Our Ref: B3031

Re: Minto Resource Recovery Facility (SSD-5339)
3 November 2021 - Request for additional information

We refer to the subject request for additional information and provide below our response to the issues raised. Issues raised are shown in green with responses provided.

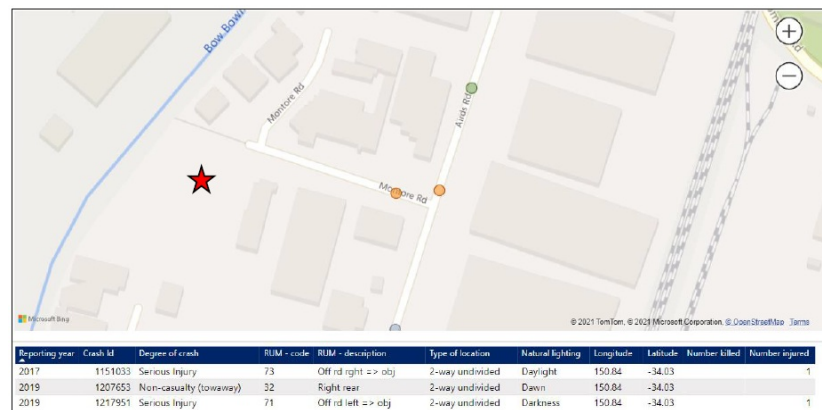
The proposed access driveway provides adequate sight lines for pedestrians as shown below.

Project No:	Drawing No:
2021/0276	2021-276-03C

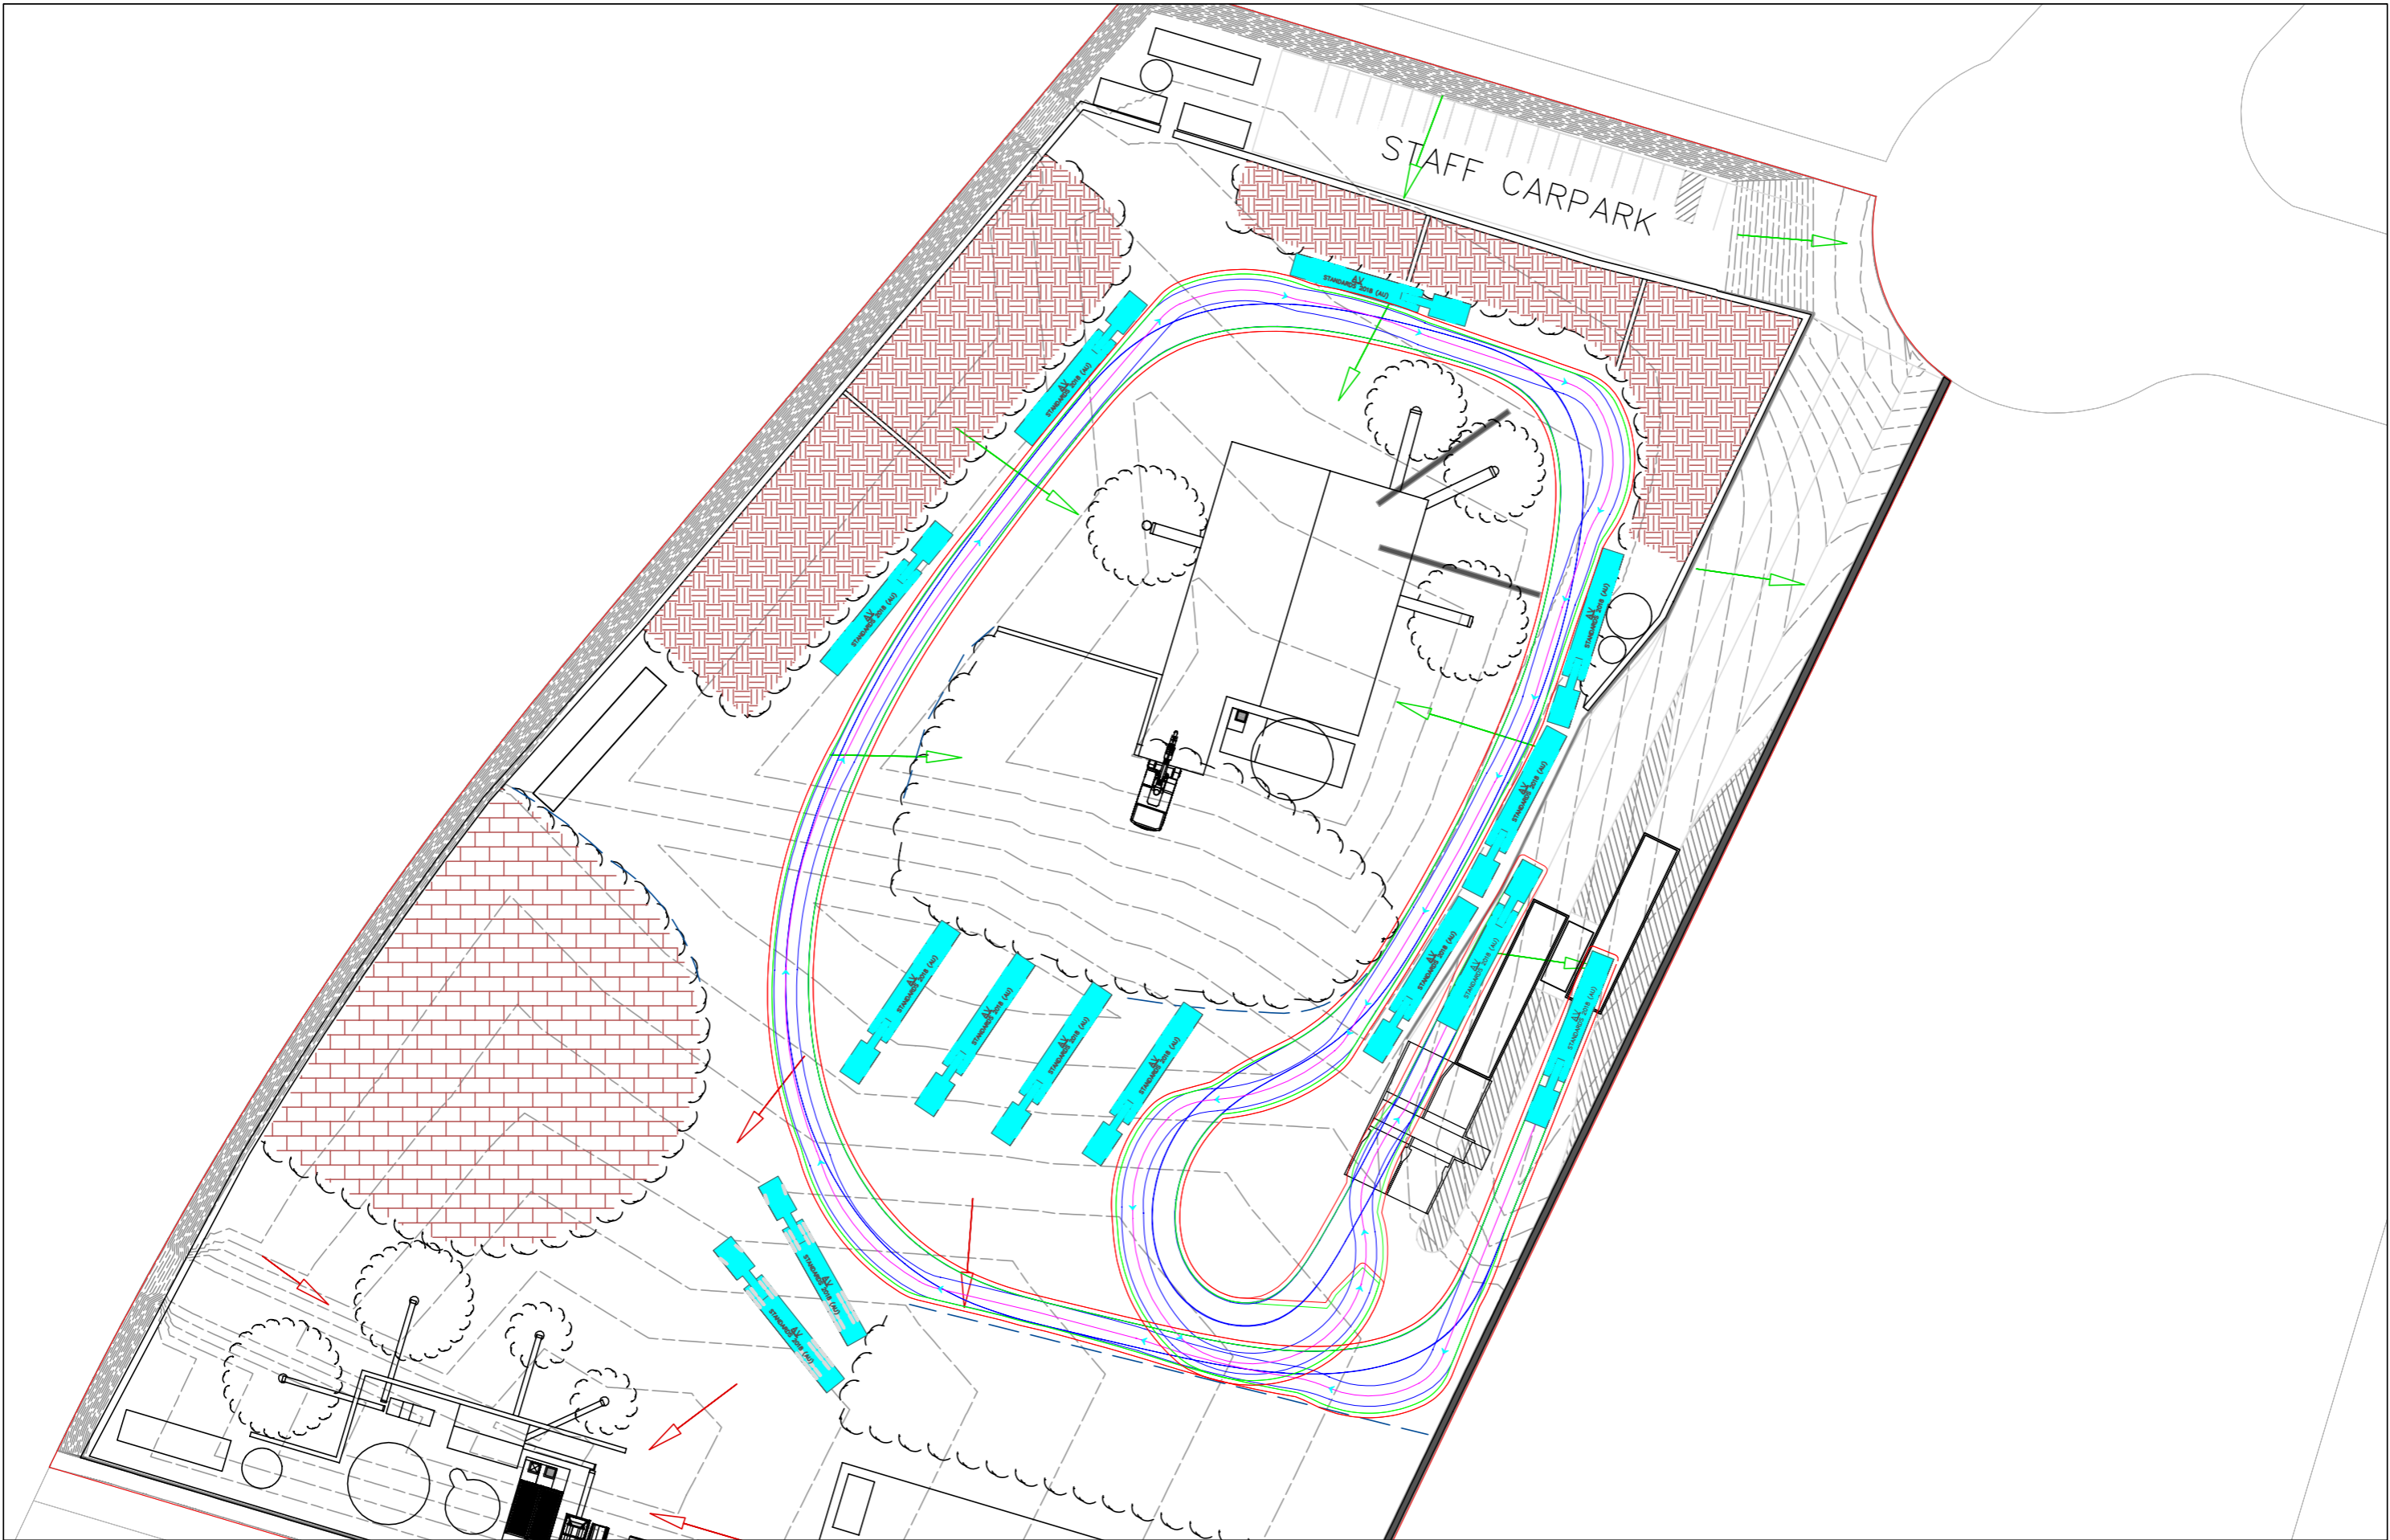
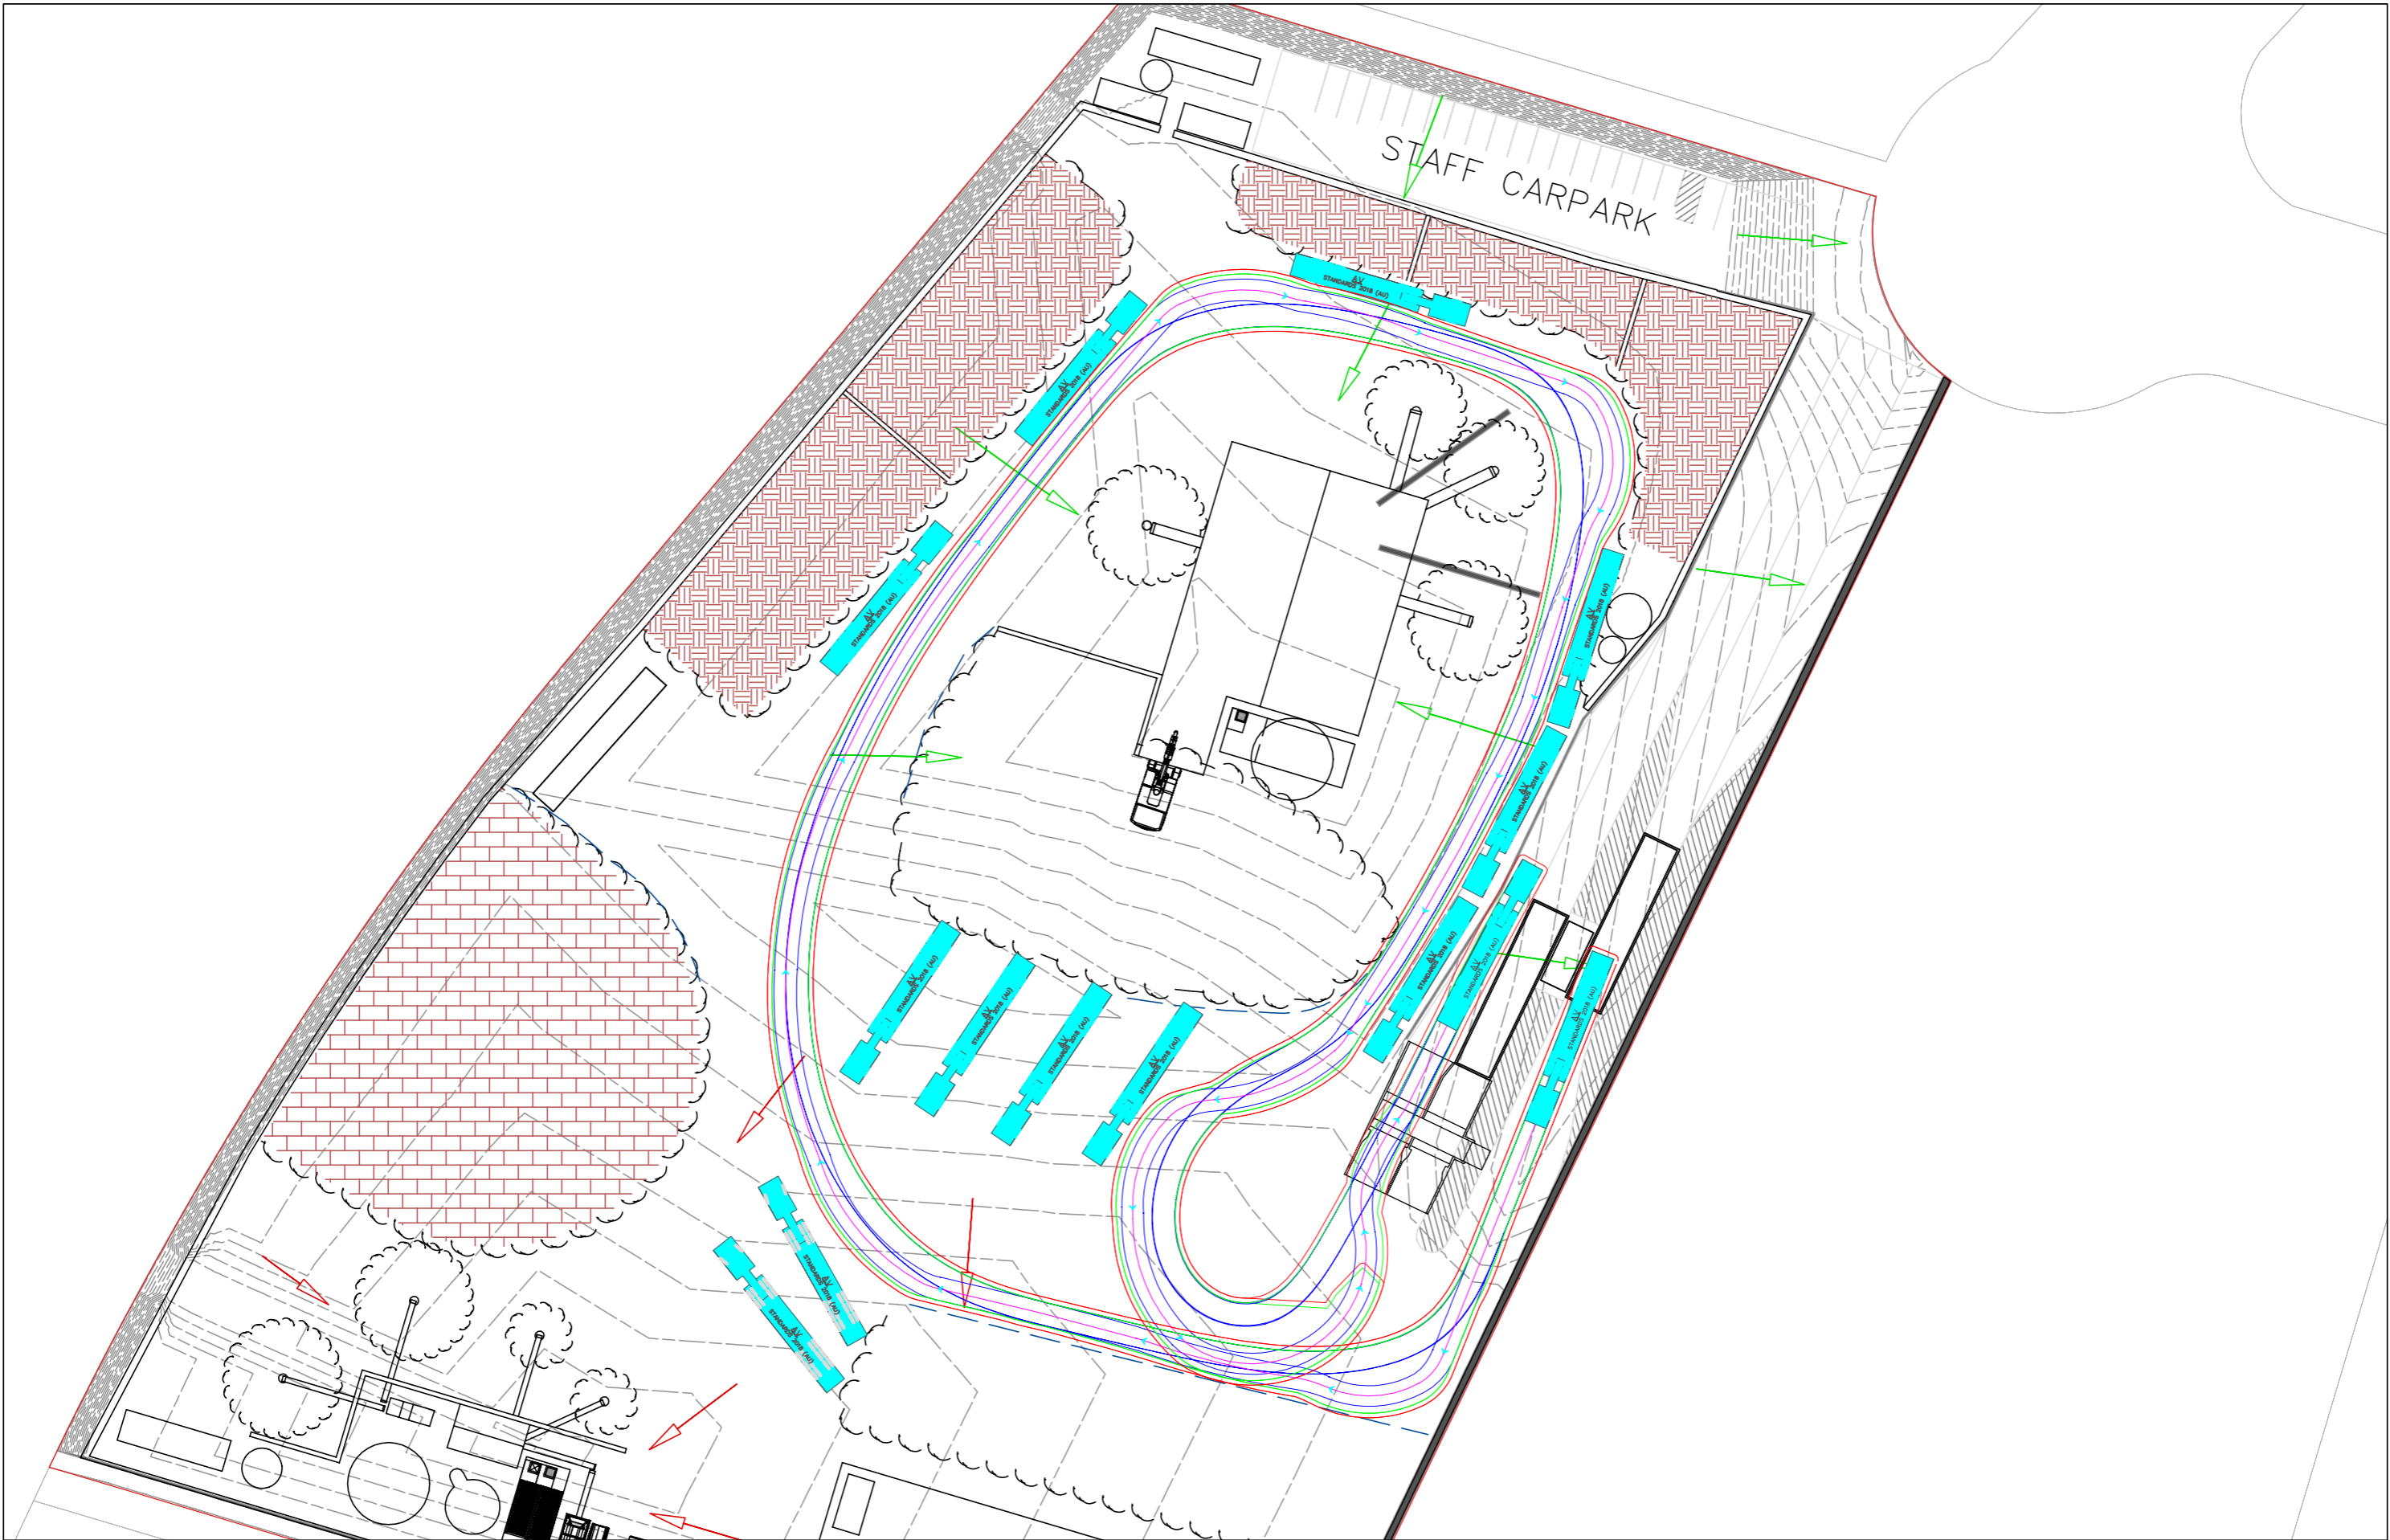
Drawing No. 021-276-03B shows the AV vehicles unloading straight into the stockpile, not unloading areas, please update the plan to show the vehicles unloading into the dedicated unloading areas. The drawing also shows two trucks unloading at once, demonstrate the two tip and spread areas will be kept separate.

Explain why the swept paths, particularly those shown entering and exiting the site, in Attachment 9 are different to those in Drawing 2021-276-03B in appendix 12 and which one is accurate.

Drawing No.021-276-03C is reproduced below.

This drawing has been prepared by the Traffic Engineer to show that Articulated Vehicles can both enter the Site and manoeuvre within the Site. The stockpiles shown on the diagram are indicative only. Material delivered to the Site, as detailed in **Table 2-1** from the Environmental Impact Statement above and in the email correspondence with the EPA, will not occur directly to the stockpile(s). Rather, material will be deposited onto the sorting area (which is a dynamic location) and after inspection pushed onto the stockpile by the front end loader.

The drawing shows trucks unloading material either at the location of the mixed waste stockpile or the sandstone/sand stockpile. Because the material deposited at each of these locations will be the same, there is need for two(2) tip and spread areas.

Modified swept path diagrams have been prepared as shown in **Attachment 2** to this letter.
